TT265 – September 18, 2006

Temporary PDI change for FLHTCUSE2 (Screamin' Eagle Ultra)

Fig. C (End Result)

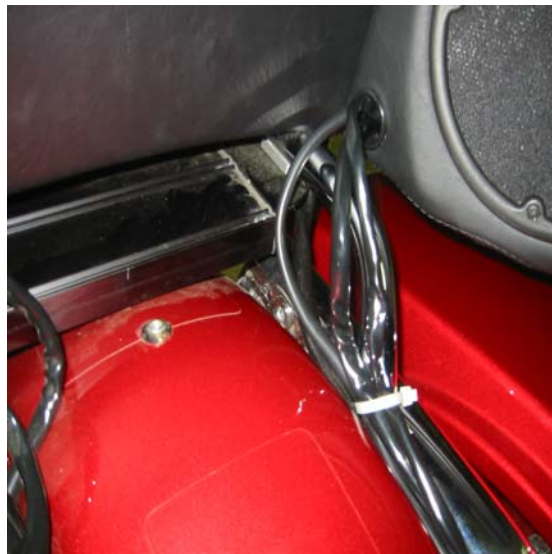
*** Since the passenger headset connector has been moved to the left speaker pod, the headset wiring and it's connector will now also enter the pod thru the same hole as the speaker wires and connector, however from the factory these connectors will be zip-tied to the tour-pak mount rail as shown below * **NOTE: zip-ties will be black from factory**

The following will be the change for the LEFT Speaker Pod:

- Cut the top T-wrap nearest to pod. Be careful not to cut conduit or wires.
- Install 2 connectors into hole in pod (**Fig. A & B**)
- Install bushing (grommet) into Pod as noted in PDI manual (**Fig. C**)

There is a planned change in the Left Speaker Pod that will make this PDI change only temporary. As we move forward you will notice bikes at PDI where the two connectors are already installed in the Pod and this extra PDI step will not be needed. Checking the wiring during PDI while the seat is off will determine if the connector insertion steps are needed.

Bottom line: **Connectors for pod components should always end up INSIDE the pod.**
